Project: 08-25-3311 HCA LSMC CAMPUS EXPANSION
2100 SE BLUE PARKWAY
LEE'S SUMMIT, Missouri 64063

RFI #026: Pedestrian Bridge Footings

PEDESTRIAN BRIDGE
STRUCTURAL SECTIONS AND
DETAILS

S211

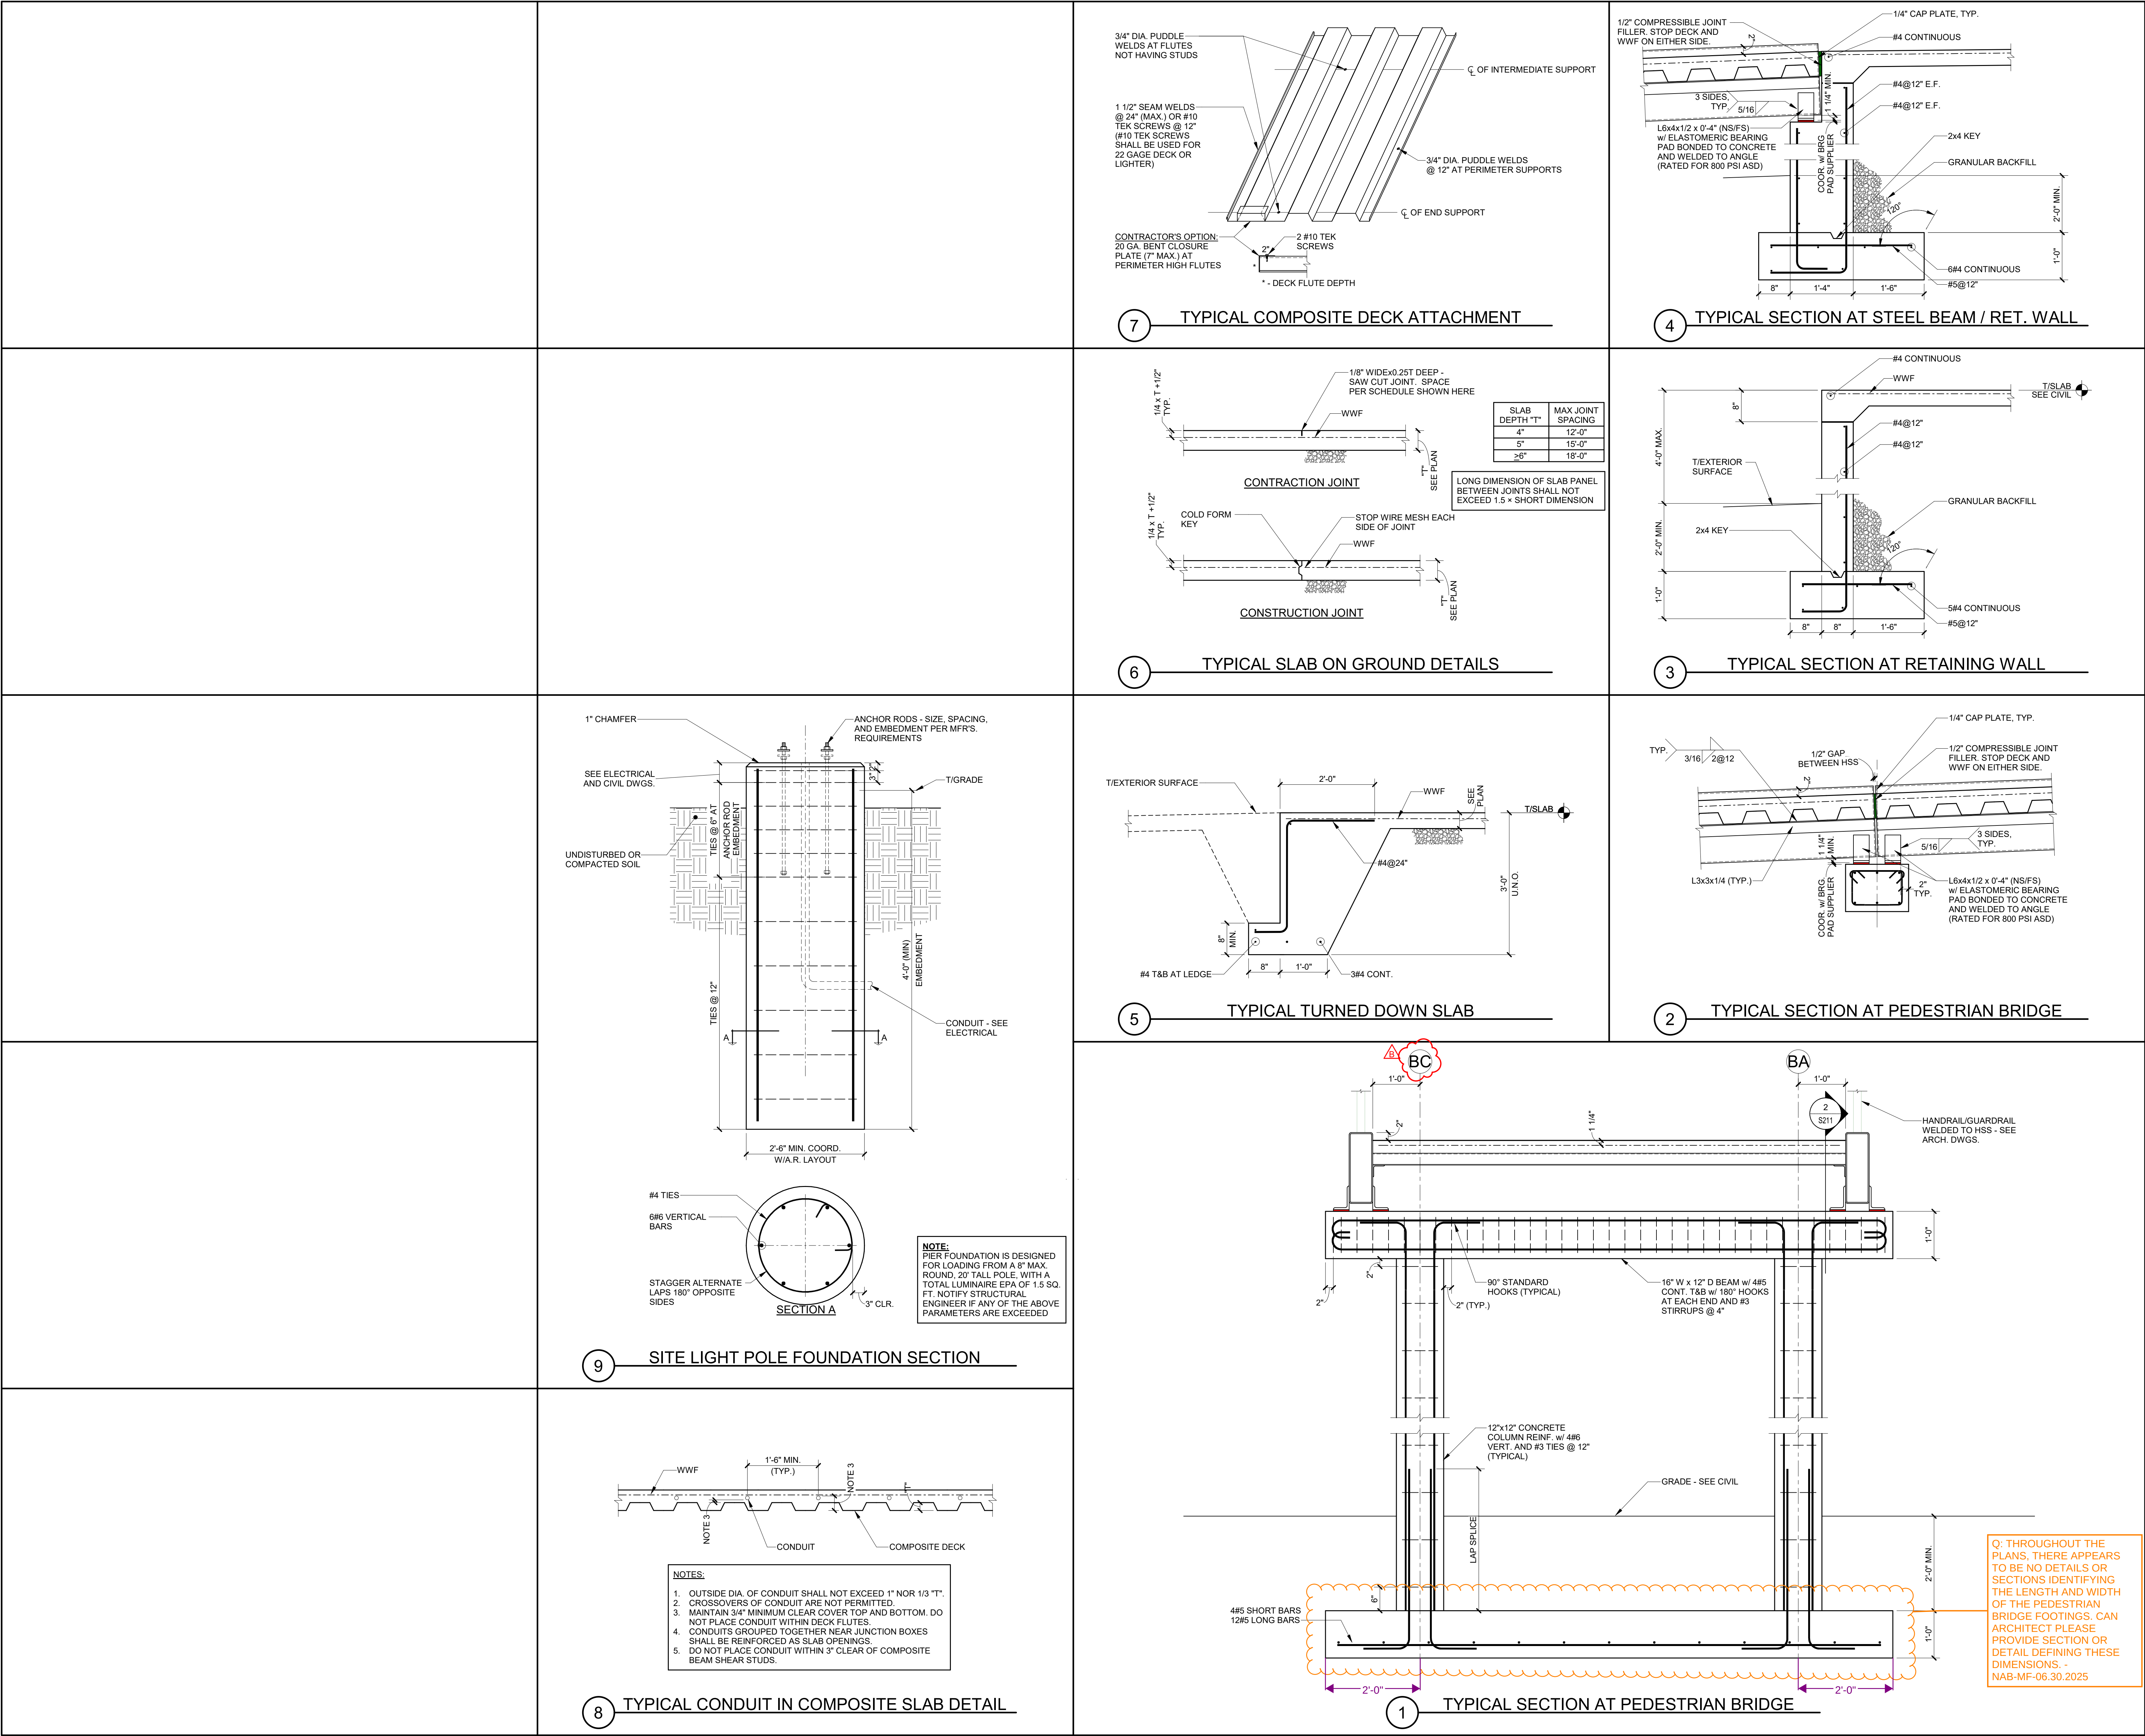
Q: THROUGHOUT THE PLANS, THERE APPEARS TO BE NO DETAILS OR SECTIONS IDENTIFYING THE LENGTH AND WIDTH OF THE PEDESTRIAN BRIDGE FOOTINGS. CAN ARCHITECT PLEASE PROVIDE SECTION OR DETAIL DEFINING THESE DIMENSIONS. - NAB-MF-06.30.2025

See the markups in the RFI document. The width of the foundations is to be 4'-0".
The length of the foundation is to be 2'-0" on either side of grid lines BA and BC.

2 PEDESTRIAN BRIDGE SECTION
1/4" = 1'-0"

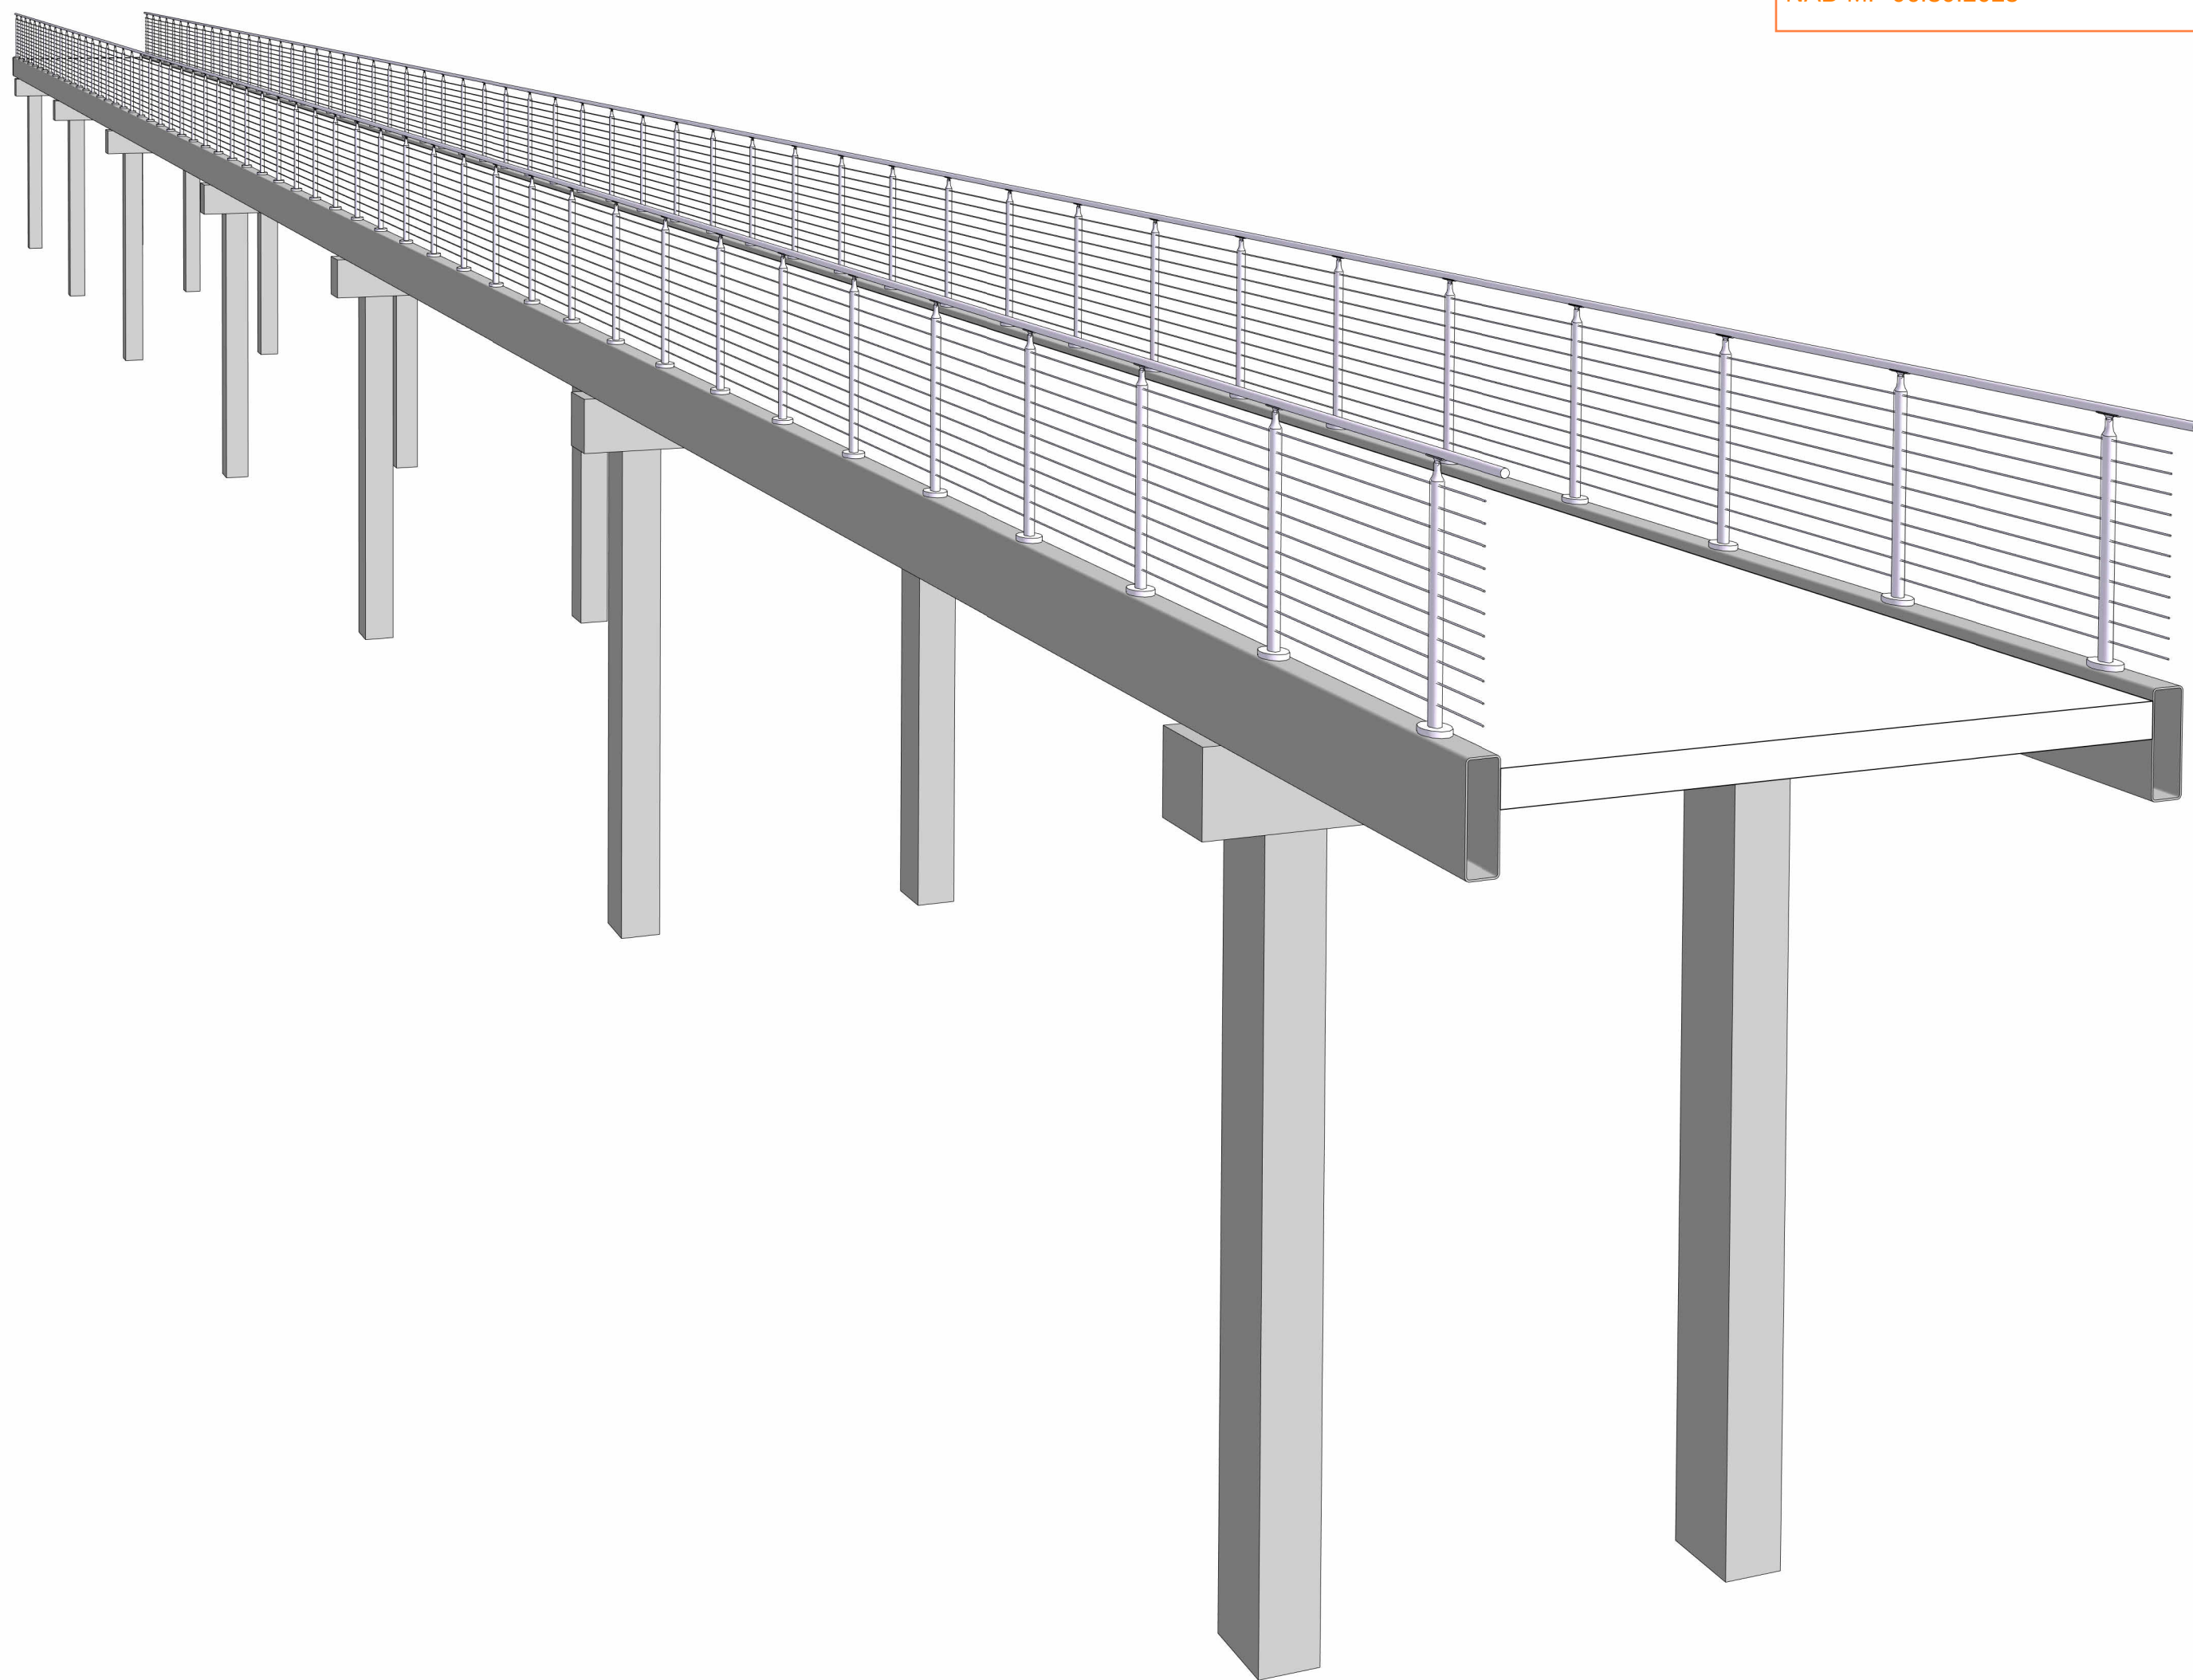
SECTION DETAIL REFERENCES THE STRUCTUAL DRAWINGS FOR DETAILS ON THE PEDESTRIAN BRIDGE FOOTINGS, HOWEVER, NO STRUCTURAL DETAILS DEFINE THE FOOTINGS LENGTH AND WIDTH. - NAB-MF-06.30.2025
